High Desert Power Project, LLC

**RE: High Desert Power Project, LLC**  
**Docket No. 97-AFC-1**  
**Response to Data Requests**

**Responses to June 29, 2009 CEC Staff  
Follow up Data Requests  
for the June 4, 2009 High Desert Power Project, LLC  
Petition for Modification to use Reclaimed Water  
at the High Desert Power Project**

**Figure 1**  
 EXISTING AND PROPOSED  
 RECLAIMED WATER SYSTEM  
 June 30, 2009

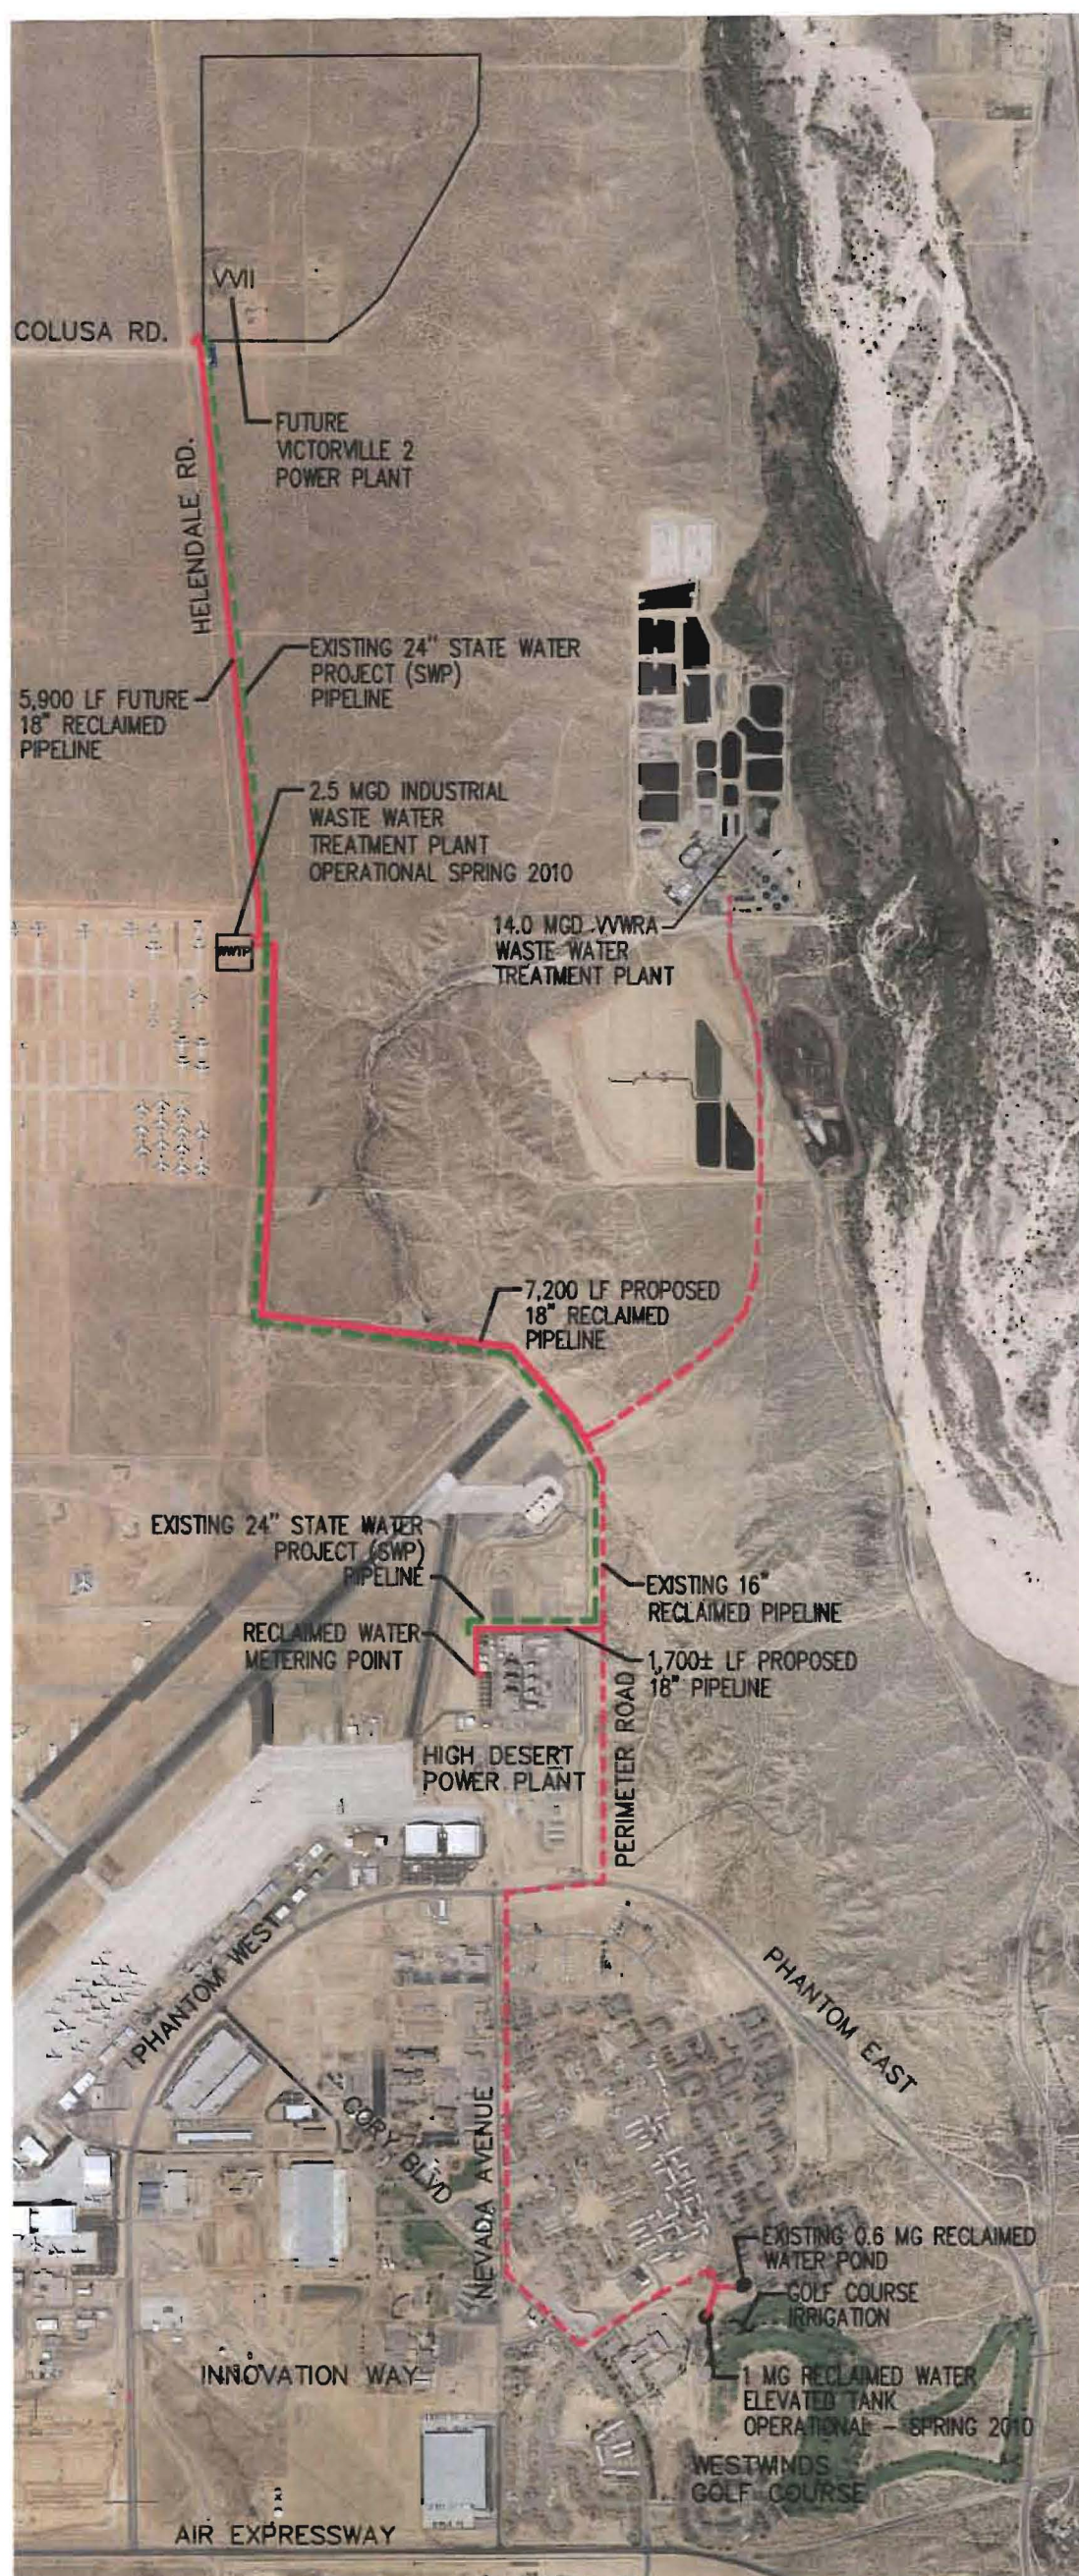
6. ***Please provide a revised Figure 1 that shows the new wastewater treatment plant that is currently under construction, the proposed route and interconnection point of the new tertiary treated recycled water pipeline, and the existing raw water (SWP water) supply pipeline and its interconnection to the HDPP facility.***

Response: See the attached revised Figure 1.
